Immingham Green Energy Terminal

9.2 Applicant's Responses to Relevant Representations

Document Reference: TR030008/EXAM/9.2

Plate 3. Locations sampled by RAC for the ALC Survey

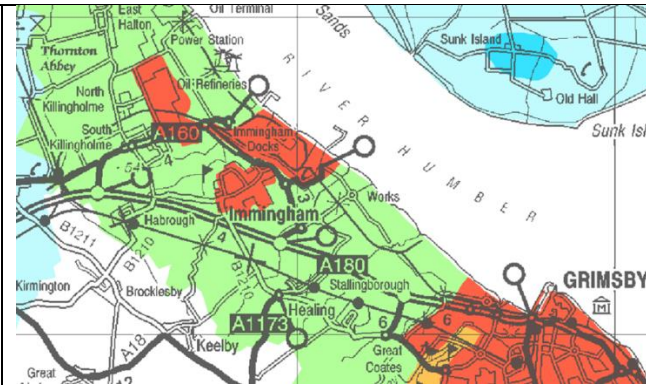
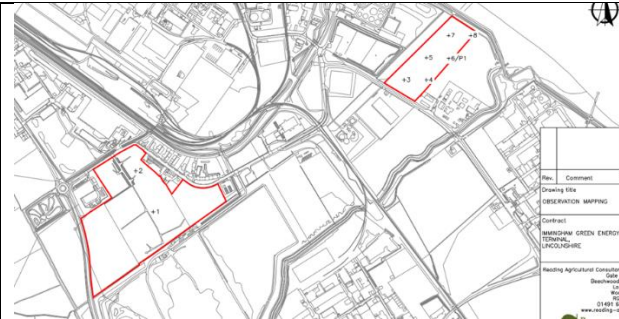
site, which is noted as being entirely grade 3b, despite only two borings being undertaken.

Additionally, it is noted that 3.1 of Appendix 21.A: Agricultural Land Classification Survey Report states that 'access was available to only part of the north-eastern parcel'. Natural England consider that further information is provided regarding why the whole area was not accessible.

There were two areas of agricultural land within the Order Limits shown in **Plate 2**. The survey boundary for both areas of agricultural land is shown on **Plate 3**. The agricultural land in both areas is classified as Grade 3 BMV land as per Natural England's Agricultural Land Classification, which has been graded (either 3a or 3b) for assessment purposes. These are (i) approximately 13ha of existing arable land to the east of Laporte Road which is in arable use and (ii) abandoned arable land slightly over 20ha to the south of Kings Road. The access and survey constraints are described further below:

Figure 4. Illustration of potential minimum separation between piling rigs

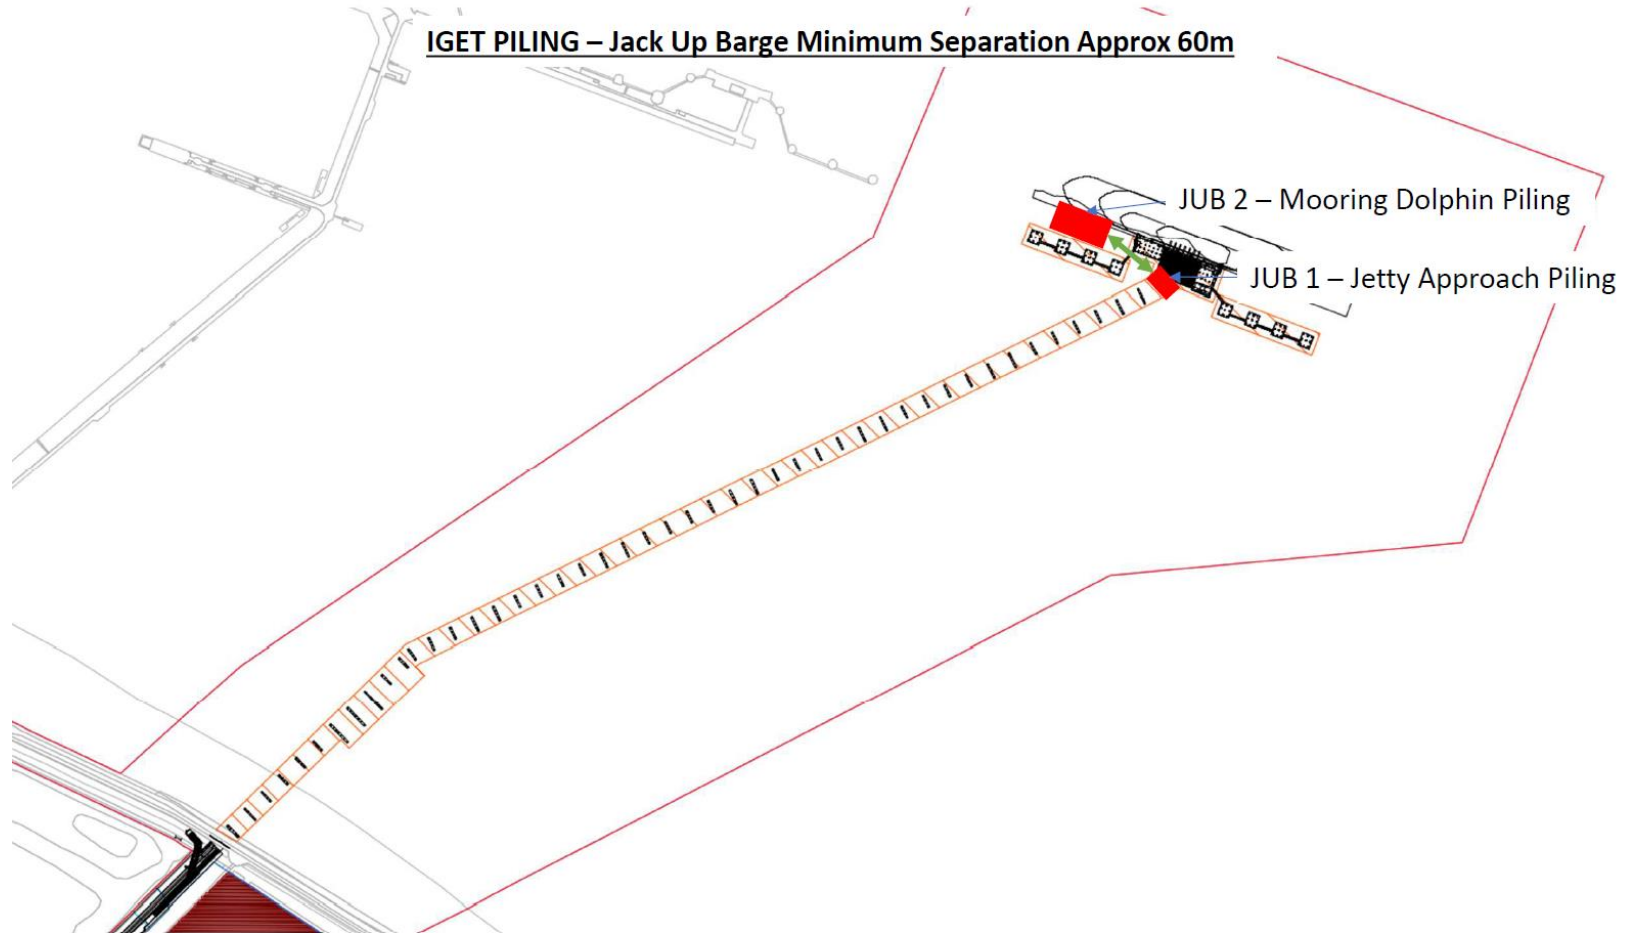
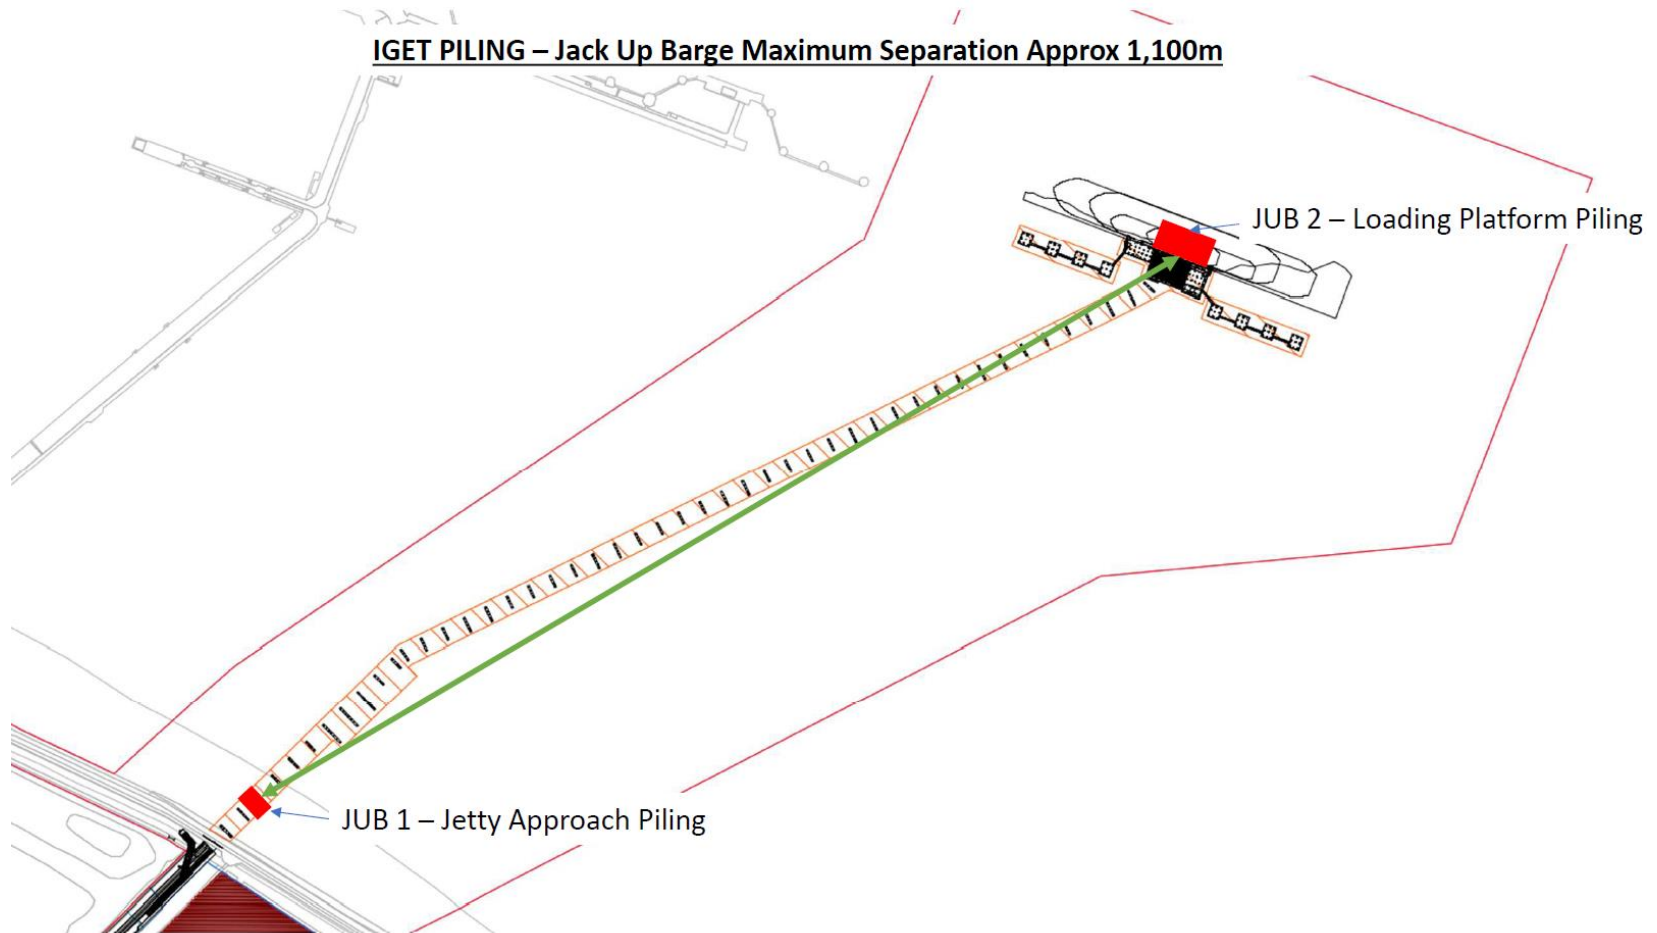
<p>4.7.9</p>	<p>For the concurrent piling scenarios, it would be helpful if the Applicant could please provide more detail e.g., in the form of a figure, showing the locations of the piling at both the jetty approach and jetty head platform, taking into consideration the minimum and maximum separation distances between the piling vessels. This would help illustrate that the chosen scenarios / modelling strategy, and the inherent idealisations / simplifications are indeed appropriate and precautionary.</p>	<p>Figure 3 and Figure 4 present the minimum and maximum separation distances between the piling rigs at the jetty approach and jetty. These are illustrative only and based on the current understanding of the construction operations.</p>
<p>4.7.11</p>	<p>Para 1.6.9 and para 1.6.10 – The MMO previously queried why the RMS source level is 10 dB higher than the SEL source level. The Applicant has responded (see Table 1) with: “The peak, SEL and RMS levels are those that were measured directly in the field and published in the literature that is referenced in Section 1.6. The SEL that is reported is effectively the SELss. The RMS metric has not been</p>	<p>Agreed. The relevant SEL_{cum} and SPL_{peak} metrics have indeed been used to assess the impacts of percussive piling noise in ES Appendix 9.B: Underwater Noise Assessment [APP-187].</p>

Figure 6. RMS sound pressure levels, with tidal flow speed plotted on secondary axis (Xodus, 2015)

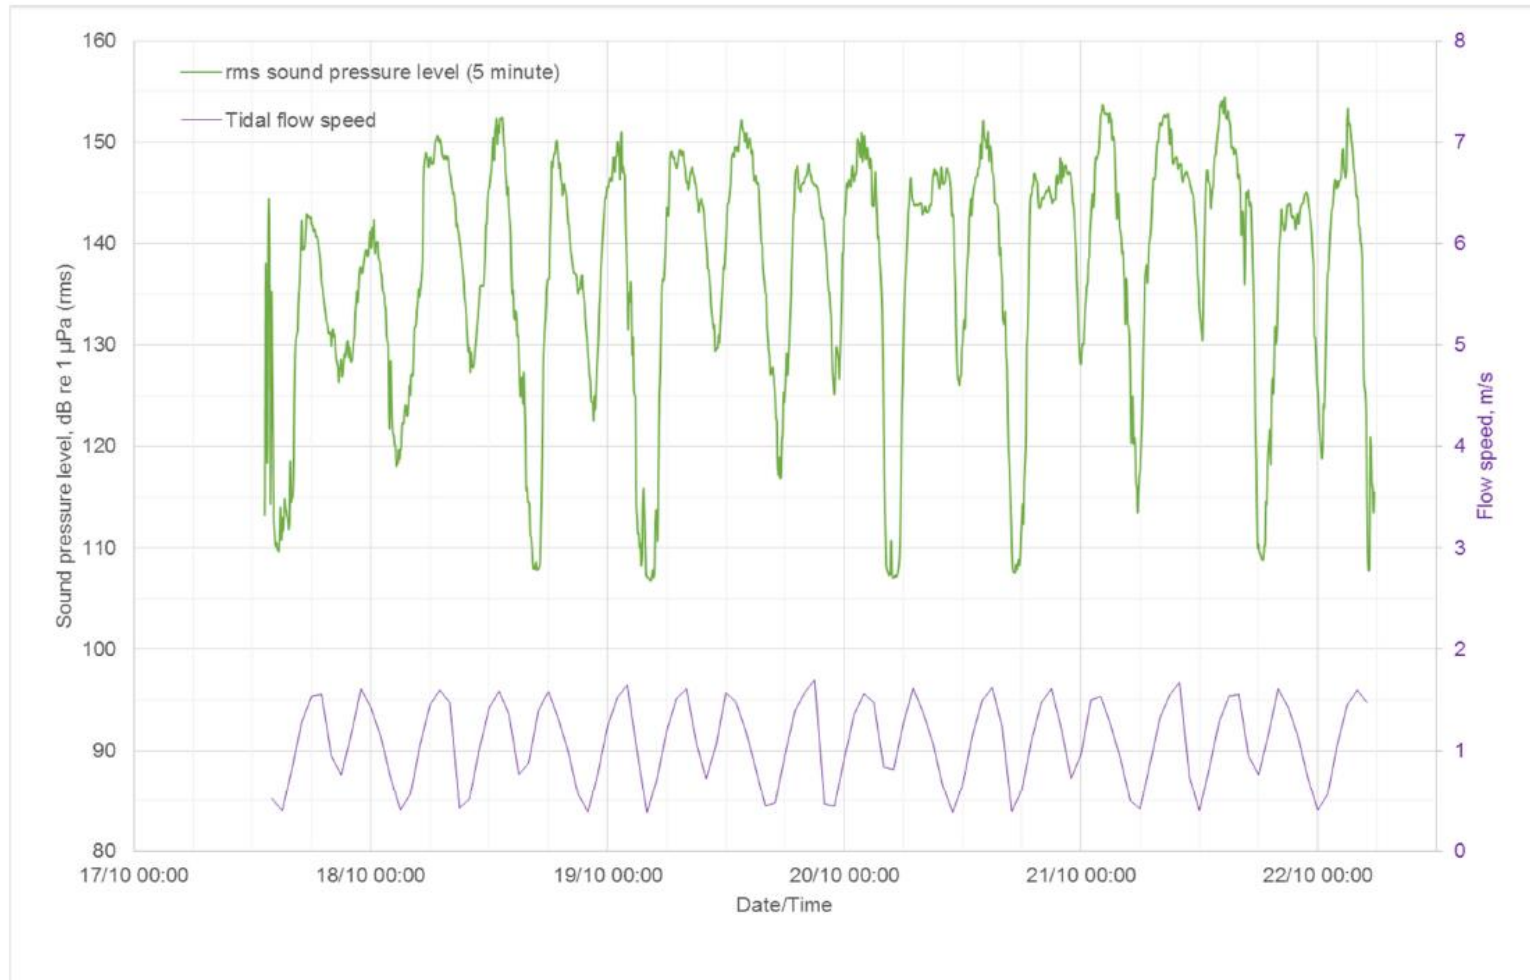
4.7.24	<p>Nevertheless, the report attempts (at various times throughout the document) to compare the received noise levels in Table 5 against the existing background noise levels – see paras 1.8.2, 1.8.3, 1.8.4, 1.9.10 and 1.9.39, 1.9.20, 1.9.49 and 1.9.27.</p>	<p>As explained in Paragraph 1.5.15 of ES Appendix 9.B: Underwater Noise Assessment [APP-187], the measured background noise levels showed a repeating pattern of peaks and troughs, ranging from 107 to 154dB re 1µPa (see Figure 5 at the end of this response). Flow speed and broadband SPL were</p>
